Posted
 Amdt. 123
 to DPR-26

The amendments revise the Technical Specifications for Indian Point Unit Nos. 1 and 2 to incorporate changes to the Facility Organization. The amendments revise the organizational figures contained in the Technical Specifications and revise the affected titles of the members of the Station Nuclear Safety Committee.

SAFETY EVALUATION BY THE OFFICE OF NUCLEAR REACTOR REGULATION
RELATED TO AMENDMENT NO. 36 TO FACILITY OPERATING LICENSE NO. DPR-5
AND AMENDMENT NO. 123 TO FACILITY OPERATING LICENSE NO. DPR-26
CONSOLIDATED EDISON COMPANY OF NEW YORK, INC.
INDIAN POINT NUCLEAR GENERATING UNIT NOS. 1 AND 2
DOCKET NOS. 50-03 AND 50-247

Figure 3.1 Independent Safety Review and Audit Organization

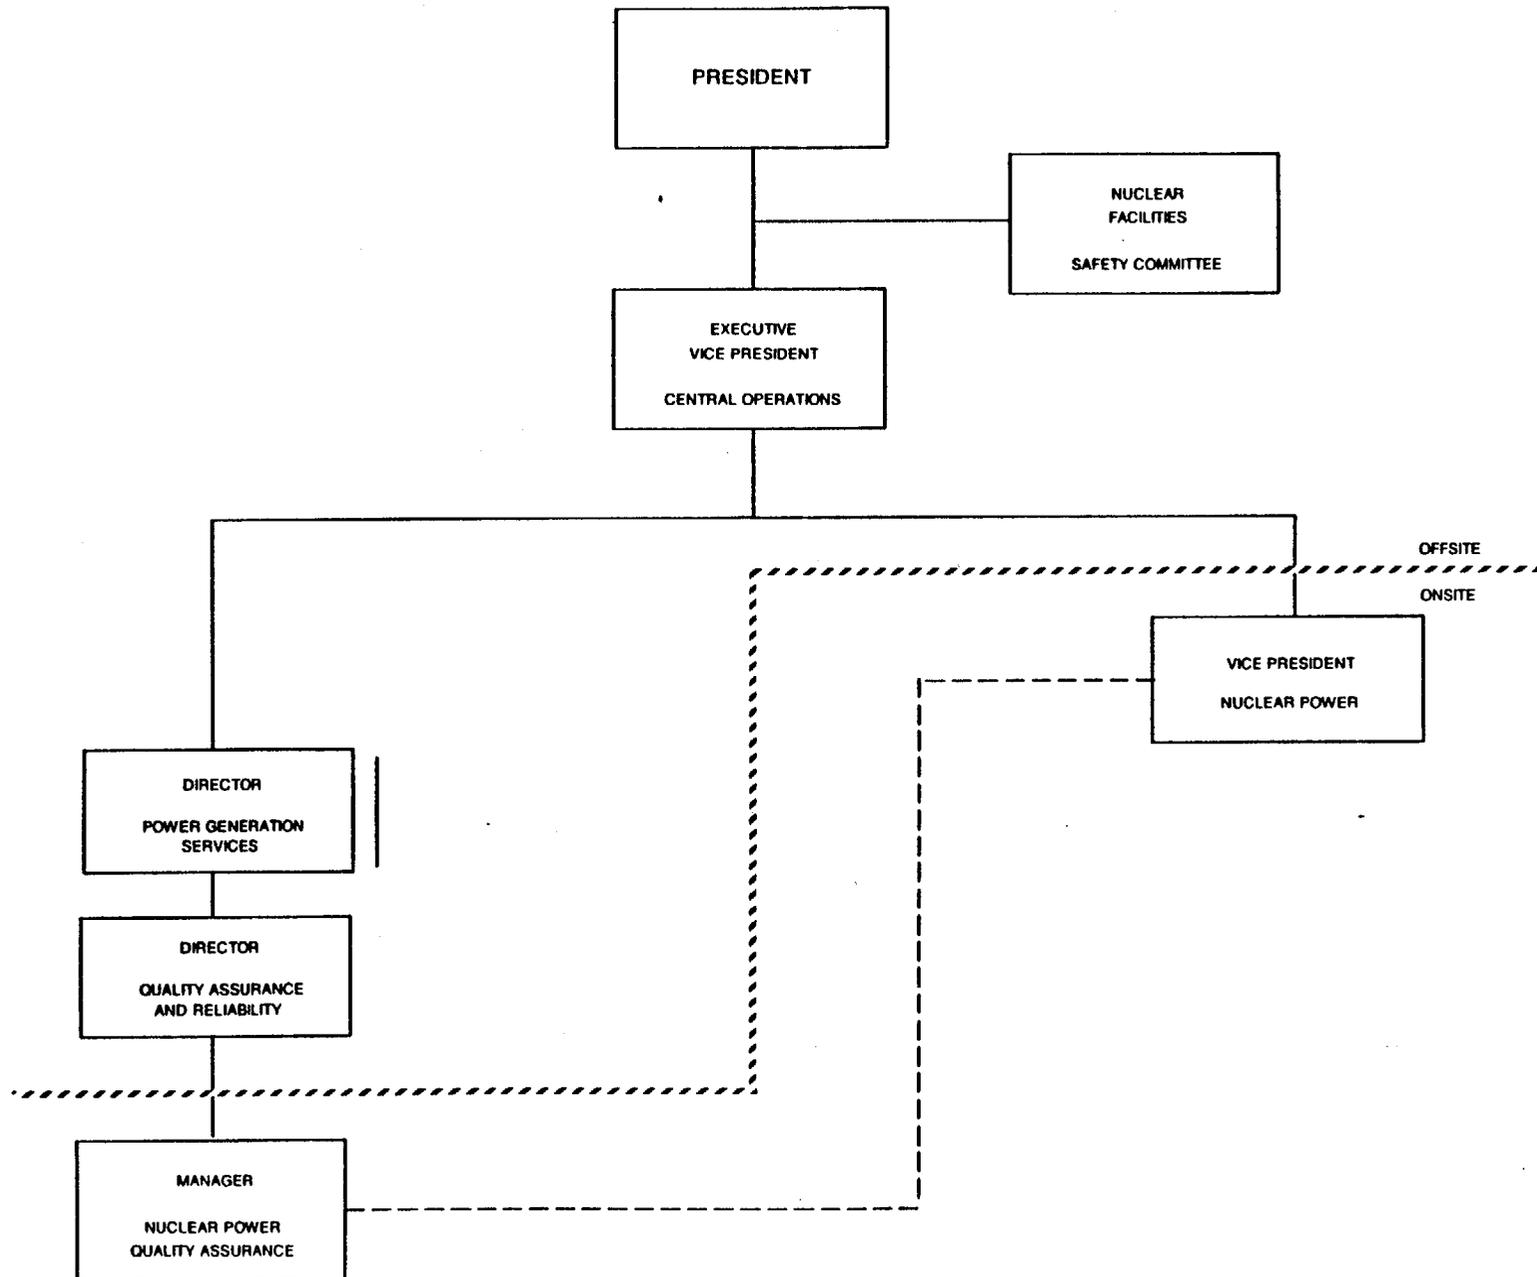
1. Figure 3.1 (IP-1)
Figure 6.2.1 (IP-2)
 - a. As a result of organizational restructuring, the offsite corporate support group, previously called the Technical Support Organization, is now called the Independent Safety Review and Audit Organization. The titles of Figures 3.1 and 6.2.1 would be changed accordingly. This is a title change only and is acceptable.

- b. The existing Technical Specifications show a Vice President, Nuclear Engineering, Quality Assurance and Reliability in the offsite organization. This position has now been abolished and replaced by a new position of Director, Power Generation Services who retains responsibilities for Quality Assurance and Reliability. The Nuclear Engineering function has been moved onsite under the Vice President, Nuclear Power. The licensee states that this organizational split offsite and subsequent consolidation of the Nuclear Engineering function onsite permits the licensee to more effectively use its personnel. Additional engineering and technical resources of the licensee, not shown on the figures, are available through the Executive Vice President of Nuclear Operations. The resulting organization provides for the same level of technical support to the

station as was provided previously. However, the engineering function has been integrated with the onsite activities where it can be immediately responsive to the needs of the Vice President, Nuclear Power. The resulting organization has not diminished the support available to the station and it is consistent with Section 13.1.1 of the Standard Review Plan. It is, therefore, acceptable.

Figure 3.2 Facility Organization

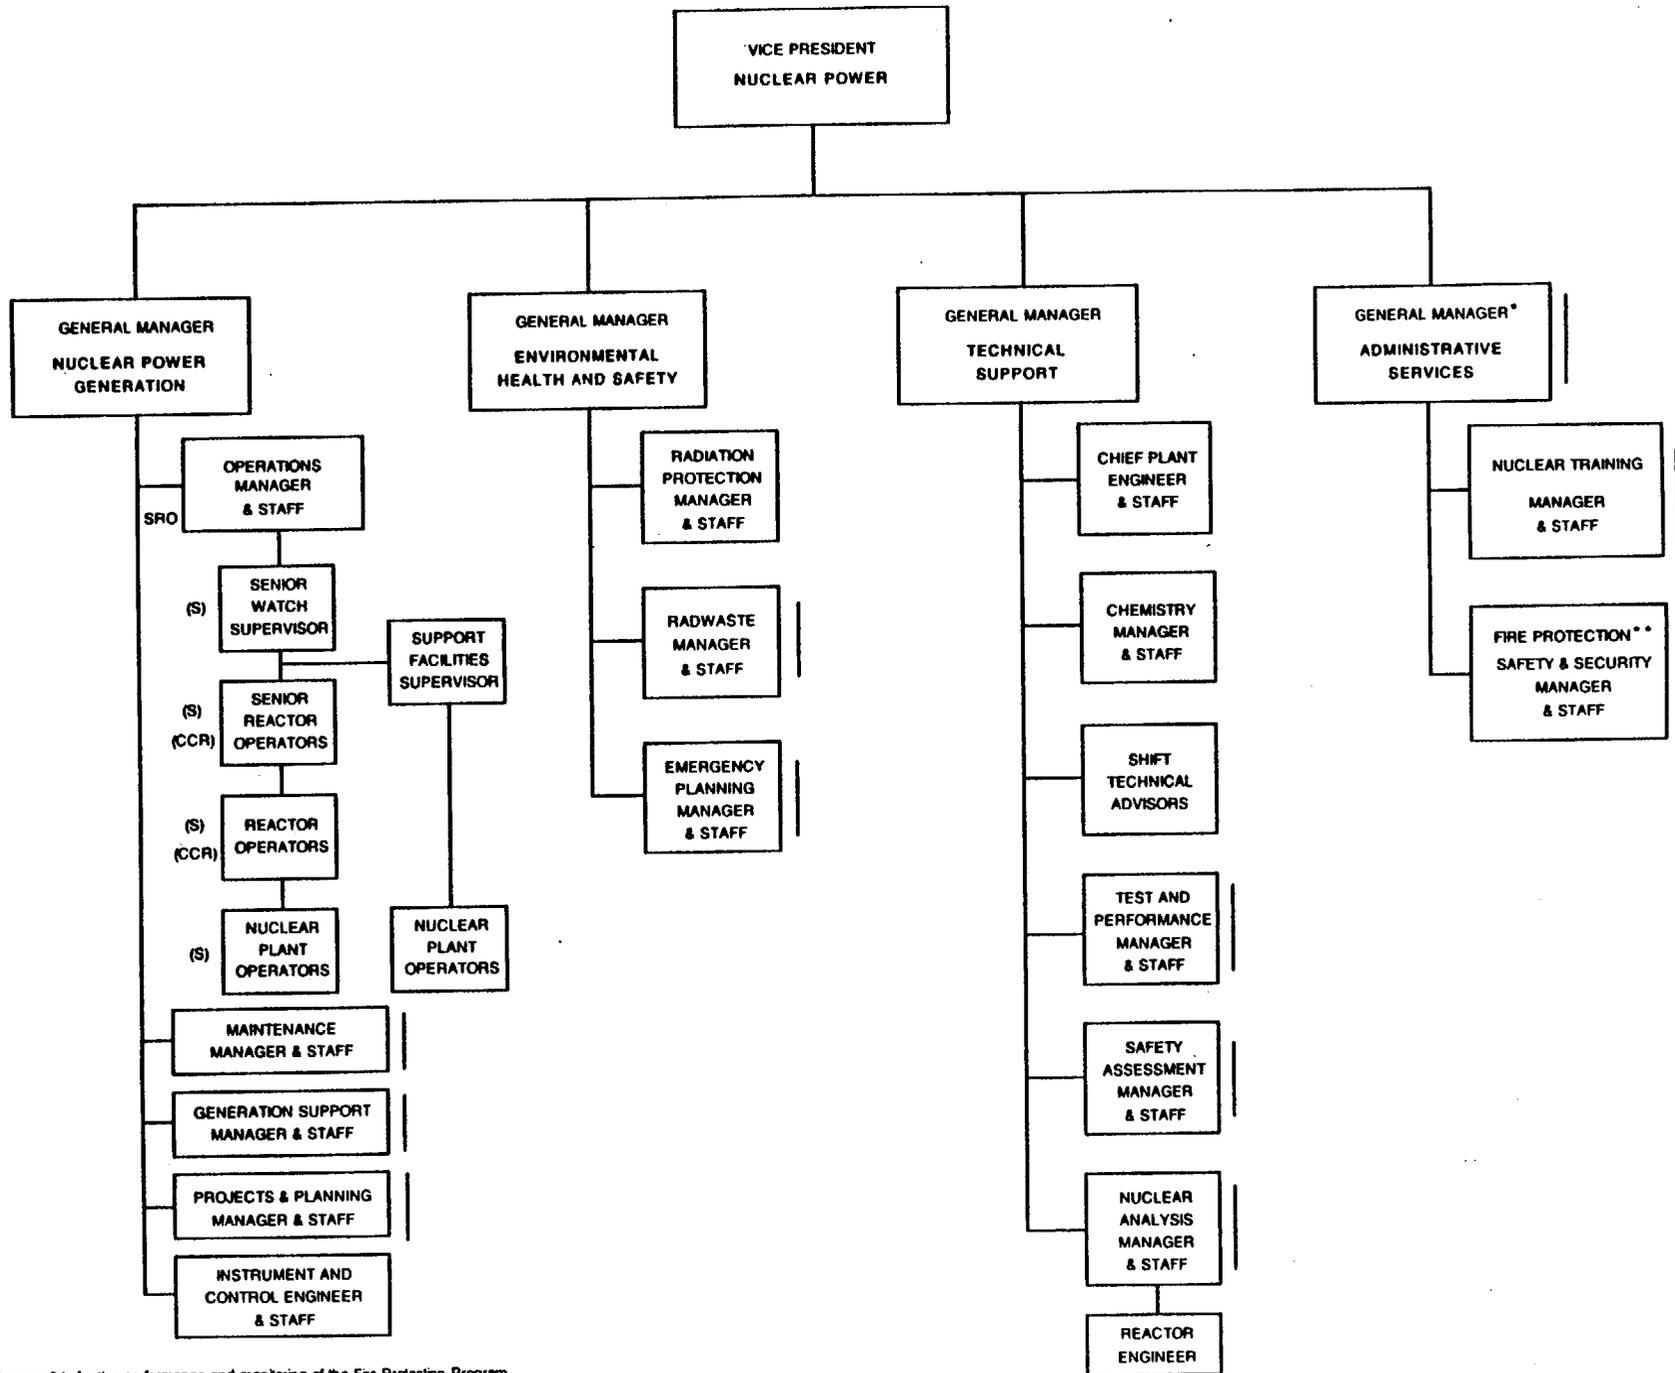
2. Figure 3.2 (IP-1)
Figure 6.2.2 (IP-2)

- a. A number of changes have been made to the onsite organization, including the following title changes:

<u>Old Title</u>	<u>New Title</u>
Chief Operations Engineer	Operations Manager
Maintenance Engineer	Maintenance Manager
Chief Technical Engineer	Chief Plant Engineer
Radwaste General Supervisor	Radwaste Manager
Test and Performance Engineer	Test and Performance Manager
Nuclear Training Director	Nuclear Training Manager
Emergency Planning Director	Emergency Planning Manager

These are title changes only and do not involve a change of function. They are, therefore, acceptable.

- b. Within the Nuclear Power Generation Department, the position of Operations Superintendent has been abolished. The Operations Manager will now directly manage the activities of the Senior Watch Supervisors, the Support Facilities Supervisors and the rotating shifts. The Operations Manager has personnel on his staff to assist in the day-to-day management of the plant operations activities. The position of Operations Superintendent is not required by the staff and abolition of this position is acceptable.

- c. The positions of Generation Support Manager and Projects and Planning Manager have been added to the Nuclear Power Generation Department. The Generation Support Manager and his staff provide additional administrative support to the department. The functions of the Projects and Planning Manager and his staff include those of the Major Projects Manager who previously was assigned to the Technical Support Department. The addition of the Generation Support Manager and the Projects and Planning Manager to the Nuclear Generation Department are intended to reduce the administrative burdens of both the Operations, Maintenance, and Instrumentation and Controls groups within Nuclear Power Generation, and the Chief Plant Engineer.

- d. The position of Nuclear Environmental Monitoring Engineer has been deleted from the Environmental Health and Safety Department and his function has been transferred to the Emergency Planning Manager.

- e. The Nuclear Engineering Department, previously located offsite, has been merged with the Technical Support Department onsite. This results in the addition of the Safety Assessment Manager and the Nuclear Analysis Manager to the staff of the General Manager Technical Support.
- f. The position of Security Administrator on the staff of the General Manager Administrative Services has been replaced by the Fire Protection, Safety and Security Manager. Responsibility for fire protection has been transferred from the Chief Technical Engineer in the previous organization to this new position.

Overall, the changes the licensee proposes to the onsite organization would result in a restructuring of functional responsibilities and a number of title changes. However, it would not delete any functions performed by the existing organization. In addition, the functions previously performed by the offsite Nuclear Engineering Department would now be performed onsite. The resulting organization is consistent with the guidance of Section 13.1.2 of the Standard Review Plan and is acceptable.
